## ZERO TURN SERIES

**Date:** September 05, 2006/August 14, 2009 **Revised On May 01, 2013 (Destroy All Previous Copies).**

**Subject:** Failure Of Welds Of The P.T.O. Clutch Torque Bracket To The Frame.

**FIGURE 3**

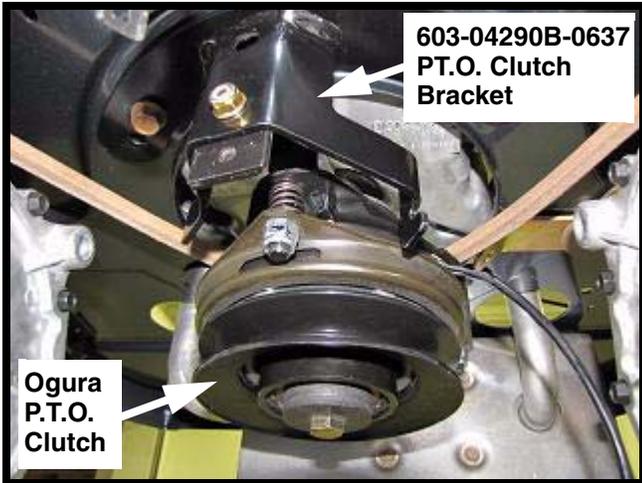
Figures 3 and 4 below show a **603-04290B-0637** P.T.O. Clutch Bracket with the **703-05845-0637** Anti-Rotation Bracket installed for anchoring an Ogura P.T.O. Clutch. See Service Advisory CC-491 for complete installation instructions of the Anti-Rotation Bracket.
